# Comments on Draft Final Comprehensive Plan Memoranda

SRRTTF

May 25, 2016

# Cost/Effectiveness of Control Actions, Routine Monthly Monitoring Update

## Add Map Summarizing Delivery Pathways

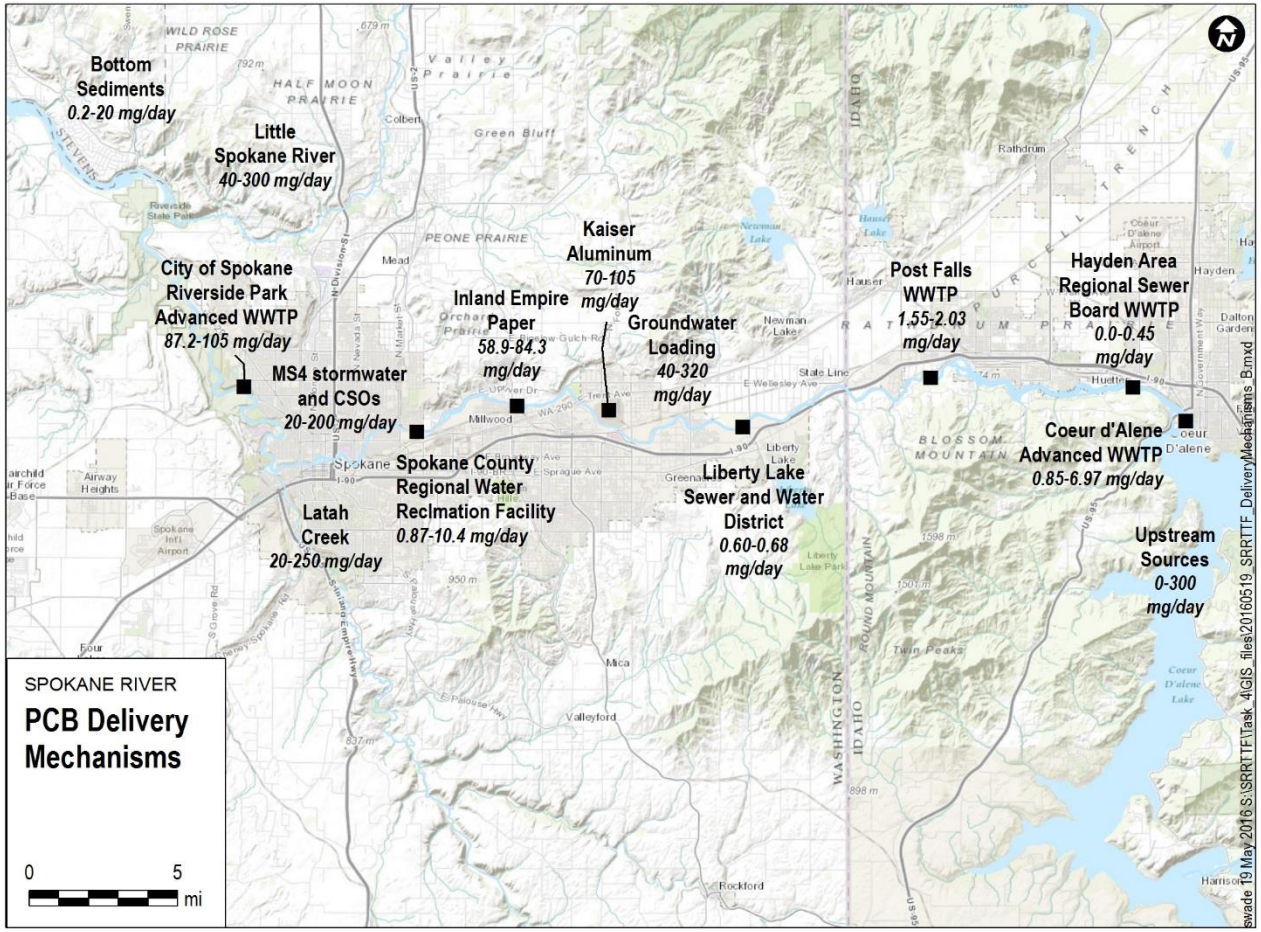
- Consideration of uncertainty
  - Lake Coeur d'Alene concentration
  - Blank correction of WWTP samples
- Wording changes
- Add map of delivery pathways
- Typographical errors
